Proposed Anaerobic Digestion Plant at Red Linhay in Halberton, Tiverton

Technical Report

On behalf of **Mid Devon District Council**

Project Ref: 38071| Rev: A – Final Issue to MDDC | Date: May 2016

Passing bay/Road widening construction detail

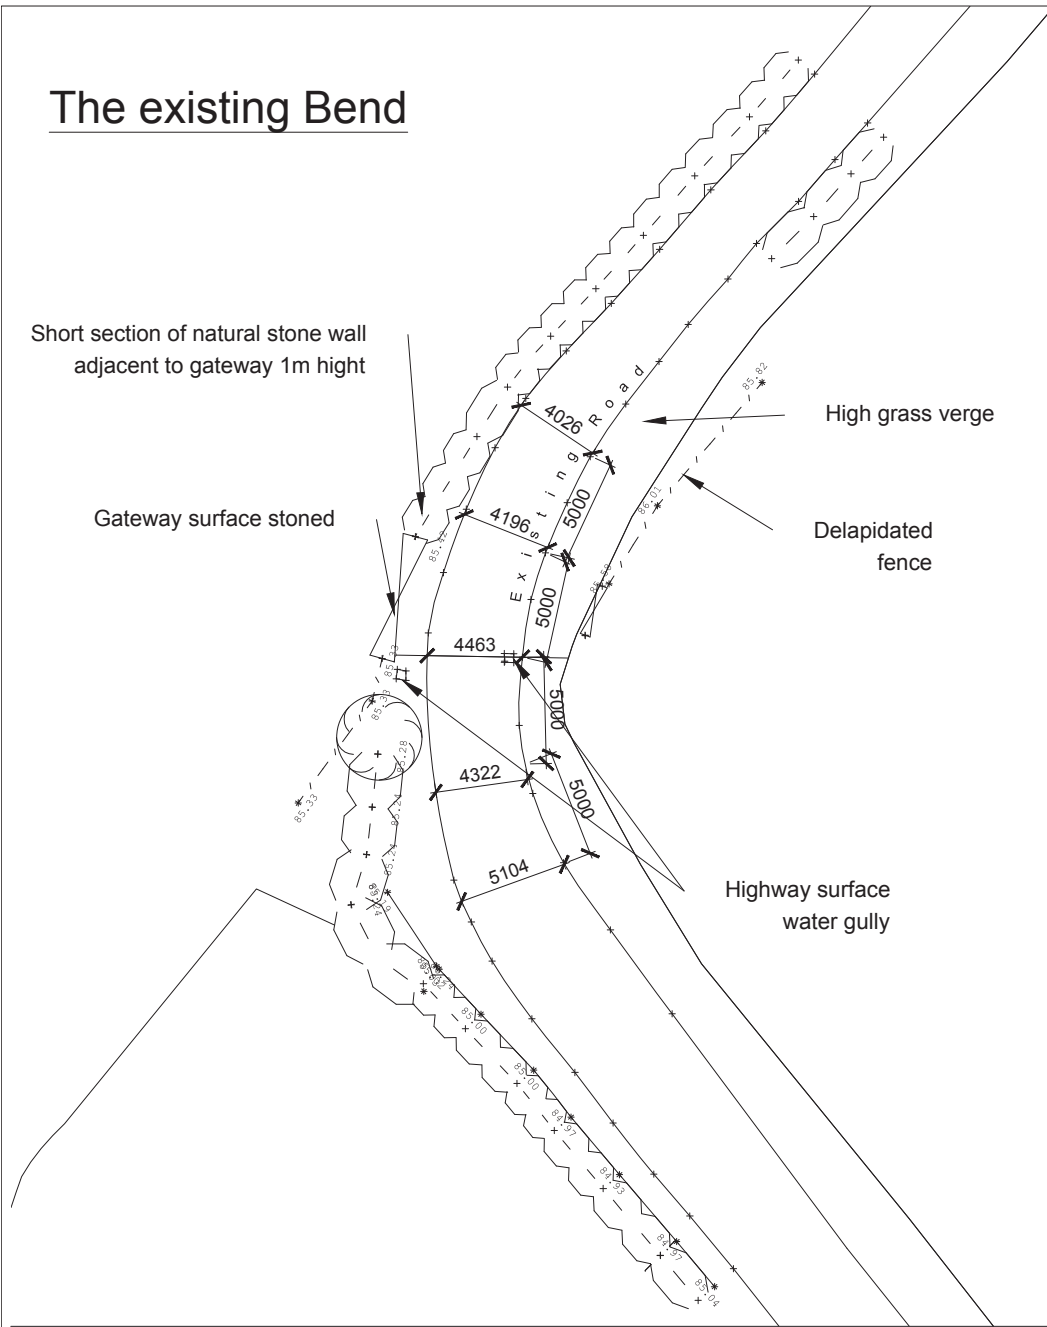
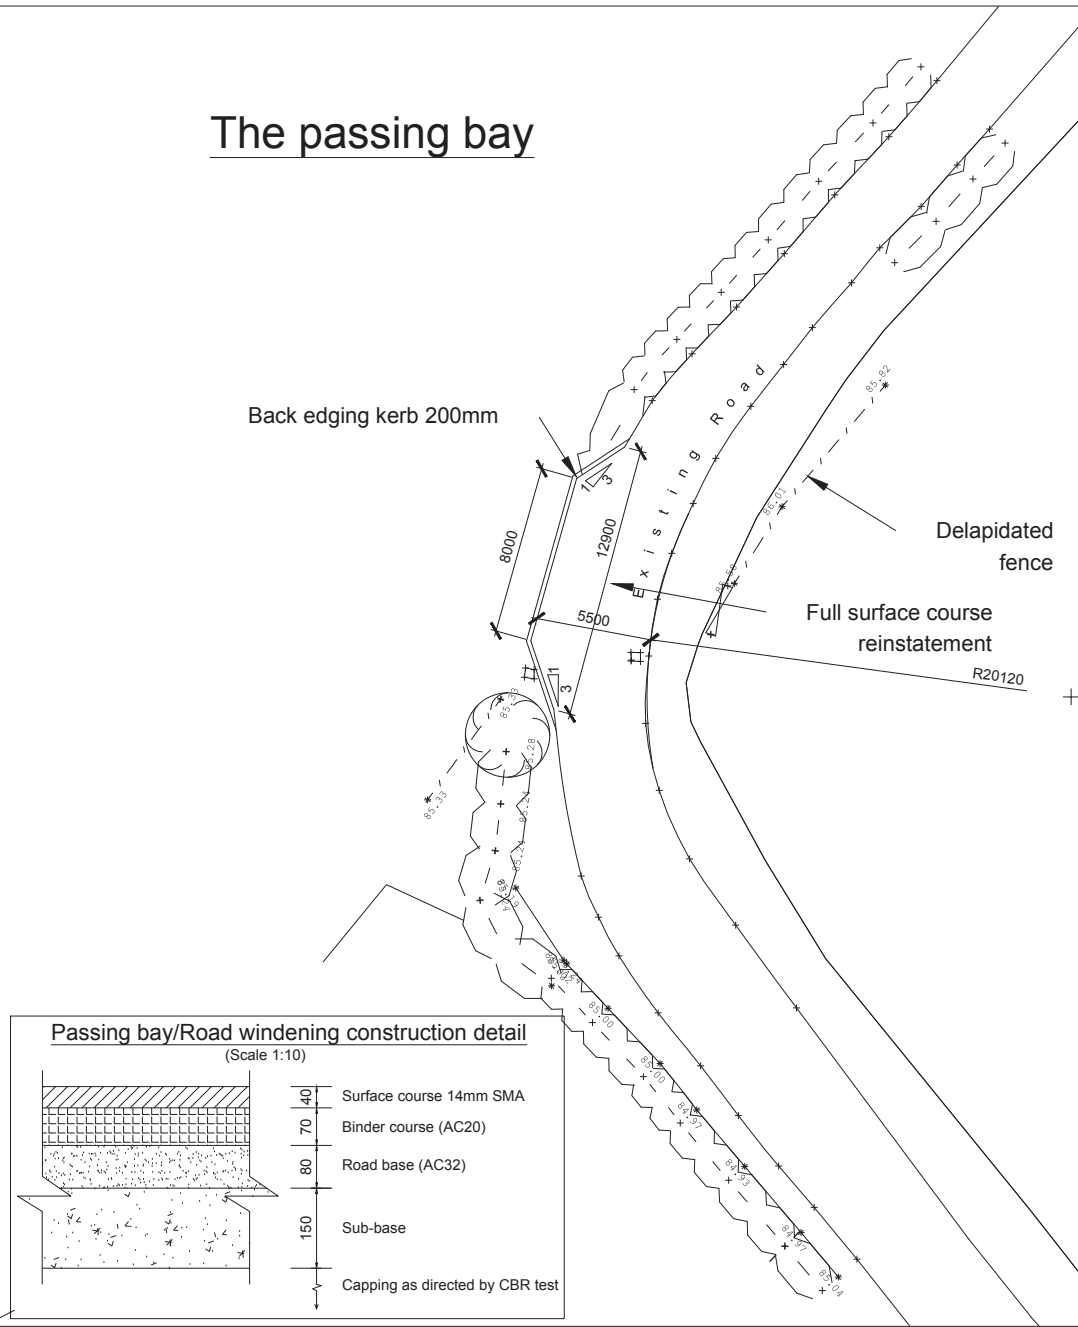
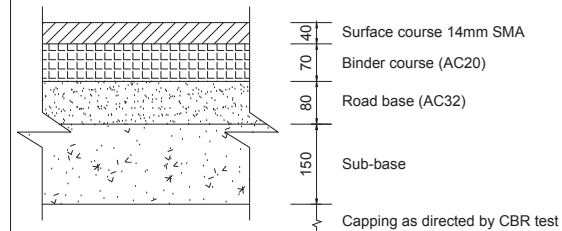
- 6.4.3 PBA recommends that at the edges of the highway, full reconstruction will be necessary to obtain an adequate width of satisfactory road surface that will allow vehicles to pass. Furthermore, it is suggested that where only reinstatement of the surface course is proposed, all surface course material is stripped back prior to resurfacing to ensure an adequate stiffness of construction. On-site observations suggest that previously new surface course layers have been laid without the previous layer being removed. These works should be completed prior to the AD plant becoming operational.

- It is noted that correspondence from DCC confirms that the proposed passing bay on Crown Hill has already been constructed. However, site observations suggest that these works have not yet been completed and that the carriageway is in poor condition, with the road construction broken down at the edges of the carriageway. PBA recommends that at the edges of the highway, full reconstruction will be necessary to obtain an adequate width of satisfactory road surface that will allow vehicles to pass. These works should be completed prior to the AD plant becoming operational.
